REMARKS

FIG. 2

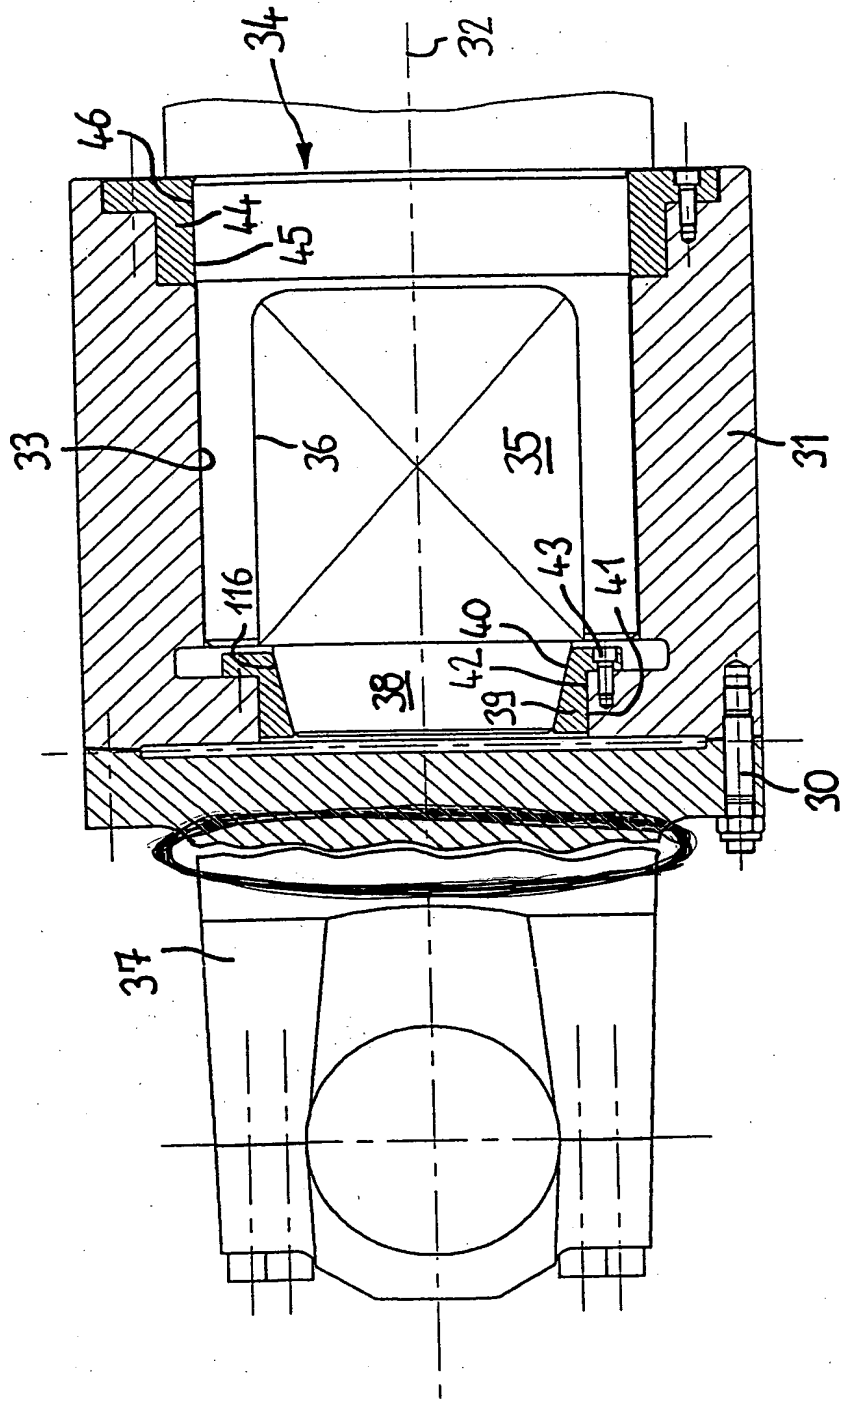
The Examiner also objected to the drawings because of an inconsistency between Figs. 1 and 2. Fig. 2 is proposed to be amended as shown in the attached photocopy to address this. Formal drawings including this proposed revision are also enclosed.

The Examiner further objected to the drawings because the lead line for numeral 116 in Fig. 2 appeared to point to two different features. In Fig. 2, the lead line for numeral 116 does not split. However, it does pass near a phantom line that illustrates the radial position of the fasteners 43 used to secure the 39 centering ring to the coupling sleeve 31. In the enclosed formal drawings, this distinction is more clearly illustrated. Thus, revision of the drawings in this regard is not believed to be necessary

Lastly, the Examiner objected to the drawings because certain features were not believed to be shown. This objection is respectfully traversed. Fig. 2 does, in fact, show two the “transmitting faces for transmitting torque” for the coupling sleeve - one is shown at the end of lead line for numeral 33, and the other is shown at the corresponding location at the bottom of the receiving bore. Also, Fig. 2 does, in fact, show the “cylindrical bore that is provided in the region of the aperture” at the end of lead line 45. The applicant agrees with the Examiner that additional views would more clearly illustrate these structures. However, it is believed that the existing drawings adequately illustrate these features of the invention.
